Item ID: D206-667-207BL Accept ***N900040100*** Setup Start ***NS1***
 Revision ID: Stop ***NS2***
 Item Name: Aft Crosstube - Mid Height 206L / L1 / L3 / L4, Blue
 Start Date: 10/28/2015 Start Qty: 1.00 ***1*** Cust Item ID:
 Required Date: 10/28/2015 Req'd Qty: 1.00 ***1*** Customer:
 Reference:

WORK ORDER NON-CONFORMANCE / UPDATE

Work Order: <u>138481</u> Part No. <u>D206-667-207BL</u> NCR No. <u>16-5627</u>		DISPOSITION Rework ☐ Scrap ☐ Use-as-is ☒ Suspected Unapproved ☐		AGAINST DEPARTMENT/PROCESS <table style="width:100%;"> <tr> <td>Skid-tube ☐</td> <td>Cross tube ☒</td> <td>Water Jet ☐</td> <td>Engineering ☐</td> </tr> <tr> <td>Machining ☐</td> <td>Small Fab ☐</td> <td>Prod. Eng. Coord. ☐</td> <td>Quality ☐</td> </tr> <tr> <td>Thermoforming ☐</td> <td>Finishing ☐</td> <td>Rec/Store/Packaging ☐</td> <td>Other ☐</td> </tr> <tr> <td>Large Fab ☐</td> <td>Composite ☐</td> <td>Supplier ☐</td> <td></td> </tr> </table>				Skid-tube ☐	Cross tube ☒	Water Jet ☐	Engineering ☐	Machining ☐	Small Fab ☐	Prod. Eng. Coord. ☐	Quality ☐	Thermoforming ☐	Finishing ☐	Rec/Store/Packaging ☐	Other ☐	Large Fab ☐	Composite ☐	Supplier ☐																																																	
Skid-tube ☐	Cros

DRAWING NO. D206-667-247	TITLE CROSSTUBE ASS'Y (206L MID AFT)	REV. A	DART AEROSPACE LTD ENGINEERING ORDER		D.E.O. NO. D206-667-247-A-1	SHEET NO. SHEET 1 OF 1	SCALE NTS
DRAWN 90	CHECKED ASS	MFG. APPR. KD	APPROVED JMD		DE APPR. H		
DATE 11.07.15	DATE 11.07.20	DATE 11.07.21	DATE 11/07/21		DATE 11.7.21

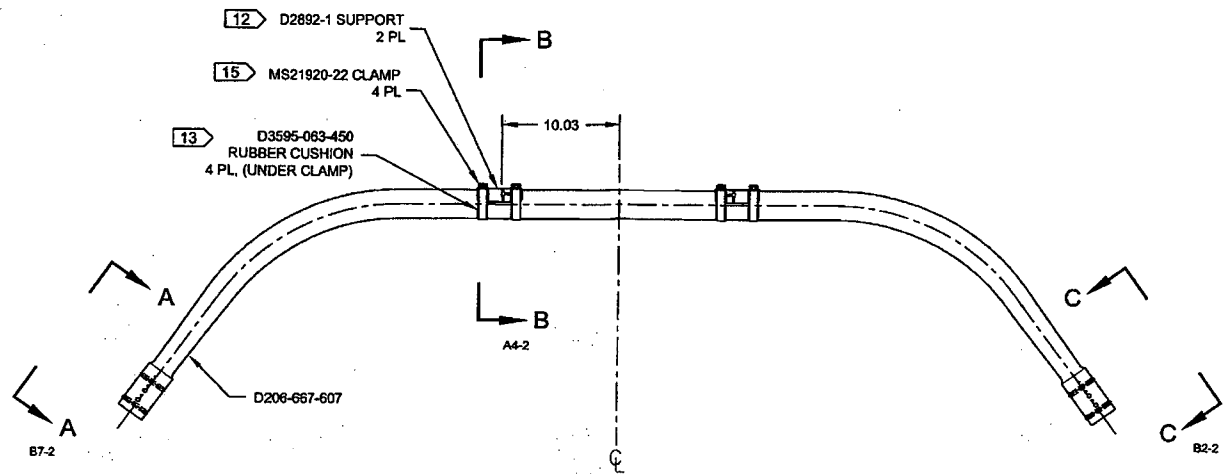
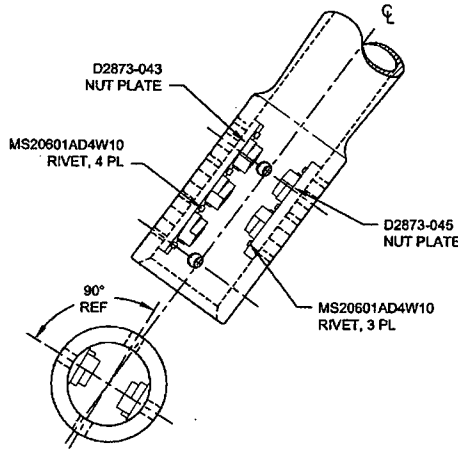
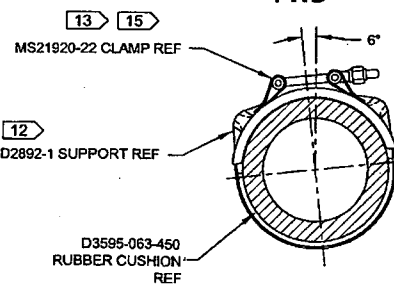
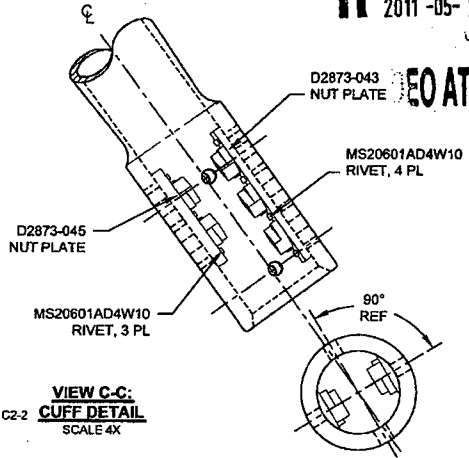
PURPOSE:

REPLACE MAGNOBOND WITH PROSEAL.

NOTE 12 & 15, SHEET 1 IS AMENDED AS FOLLOWS:

IS:

Item	Qty -247	Part Number	Description
9	A/R	PROSEAL 890 B-2	SEALANT, AMS-S-8802 CLASS B-2

- 12) TO INSTALL D2892-1 SUPPORT: ABRASE MATING SURFACE OF SUPPORT AND CROSSTUBE WITH 180-GRIT SANDPAPER AND REMOVE RESIDUE WITH MEK (OR EQUIVALENT). APPLY A 0.04" TO 0.07" THICK LAYER OF PROSEAL 890 CLASS B-2 (OR AMS-S-8802 CLASS B-2) SEALANT TO MATING SURFACE OF SUPPORT.
- 15) TORQUE CLAMPS 80 TO 100 IN-LB. ENSURE AT LEAST 1.5 THREADS SHOWING IN SAFETY AND THAT NUT HAS NOT BOTTOMED-OUT AFTER TORQUING. **PRIOR TO PACKAGING, RE-CHECK TORQUE ON CLAMPS AFTER PROSEAL 890 SEALANT HAS CURED FOR 72 HOURS.**
